Project	IEEE 802.16 Broadband Wireless Access Working Group < http://ieee802.org/16 >	
Title	Minimization of Handoff interruption time optimizing IP Address Assignment Procedure	
Date Submitted	2004-05-04	
Source(s)	Dongkie Lee, DongIl Moon, DongRyul Lee, JongKuk Ahn, Sungho Ha SK Telecom 15F, Seoul Finance Center, 84, Taepyungpro 1 ga, Chung-gu, Seoul, 100-768, Korea	Voice: +82-2-6323-3147 Fax: +82-2-6323-4493 [mailto: {galahad,dimoon,drlee,jgahn,ss23}@sktelecom.com]
Re:	Response to IEEE 802.16-04/19 (Recirculation Ballot #14a Announcement)	
Abstract	To minimize the handoff interruption time, Packet Zone ID concept is introduced. Packet Zone ID is broadcasted by BS. When BS receives previous PZID in the RNG-REQ by the MSS, BS decides whether new IP address assignment/Mobile IP registration is required or not. Then BS notifies MSS whether DHCP or Mobile IP procedure may be skipped in the RNG-RSP message. The basic assumption behind this is that decision on IP address change in BS-side is cheaper than in MSS-side, which necessitates at least 1 message exchanges over air interface.

Minimization of Handoff interruption time optimizing IP Address Assignment procedure

IEEE C802.16e-04

Figure 1 Packet Zone ID Grouping example

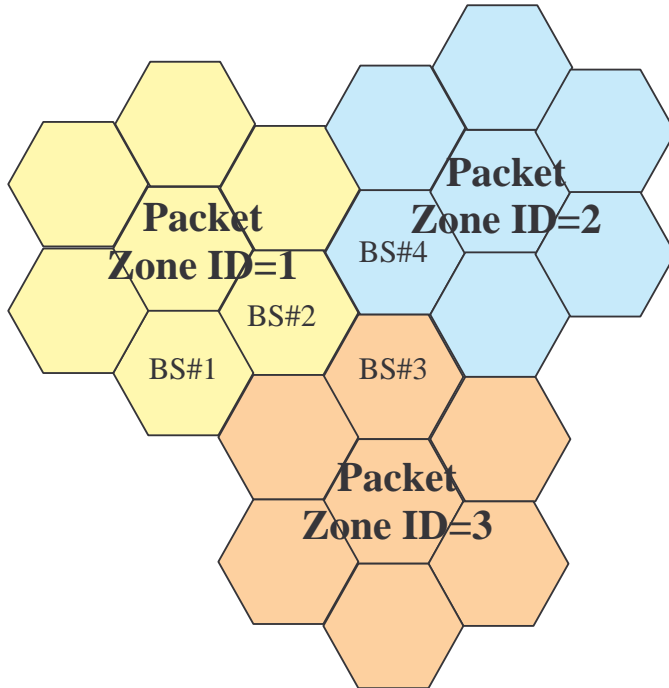
The BS's are divided into logical groups called Packet Zone which is in the same subnet for DHCP case and/or is managed by the same Foreign Agent. A BS belongs to one and only one Packet Zone ID.

Handoff Direction(Serving BS →Target BS)		IP Address Refresh
BS#1	BS#2	Not Required
BS#2	BS#3	Required
BS#3	BS#4	Required
BS#4	BS#2	Required

The basic assumption behind this is that performing decision on IP address change in BS-side is better than in MSS-side, which necessitates at least 2 message exchanges over air interface.
